SERVICE INFORMATION BULLETIN

Correction to J08E Engine Workshop Manual

Starter Assembly Mounting Nuts Torque Correction

COMPONENT LOCATOR

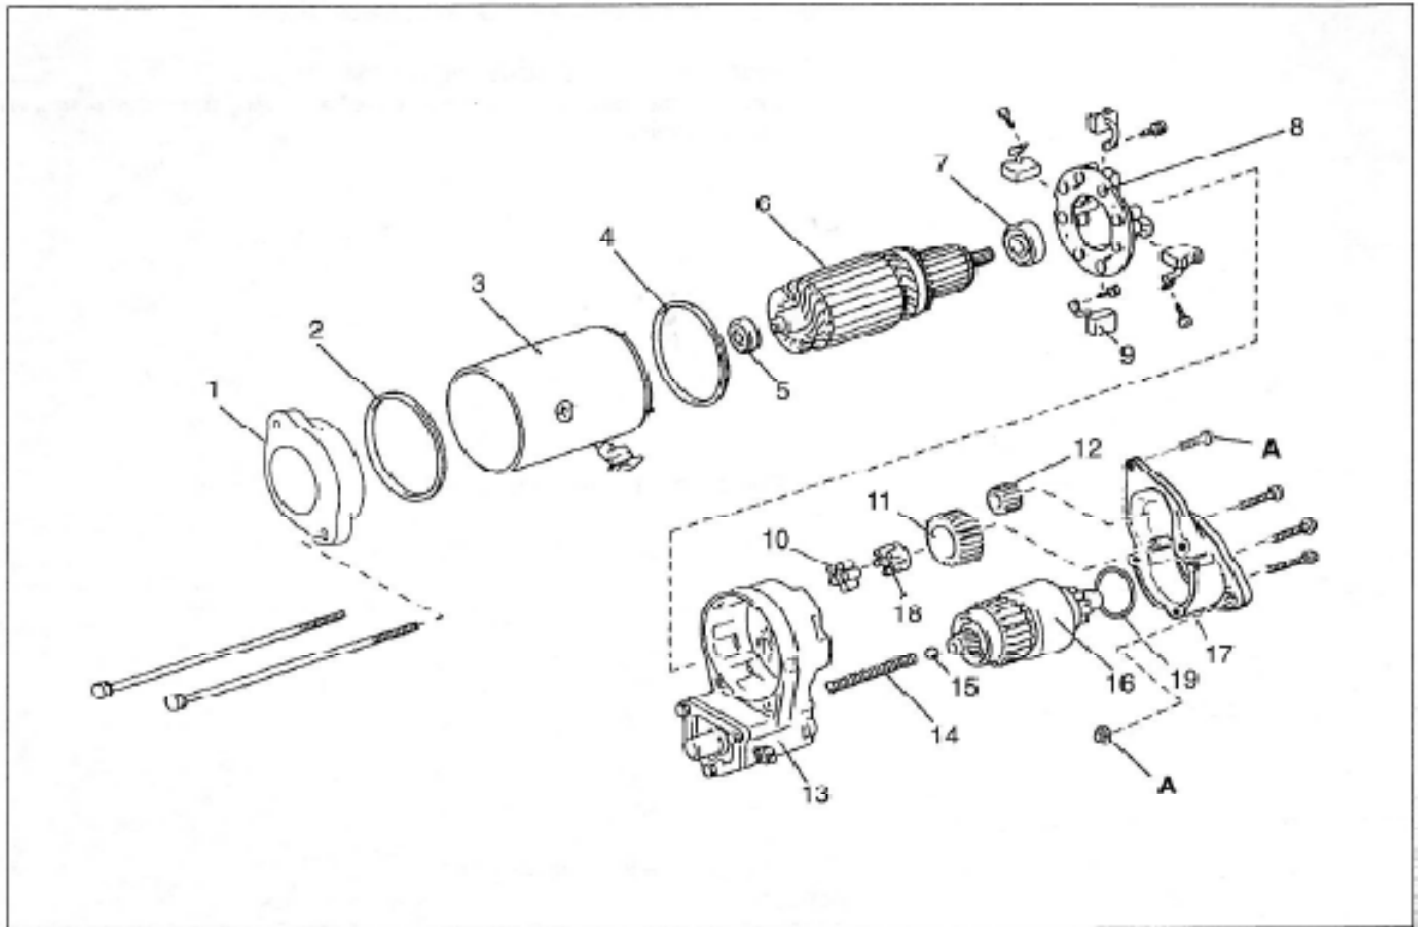
Correction to the tightening torque of the of the mounting nuts for the starter assembly. For details of this change, refer to Page 2 of this bulletin.

A ~~55 {550, 40}~~

**Correct torque:
154 {1,570, 114}**
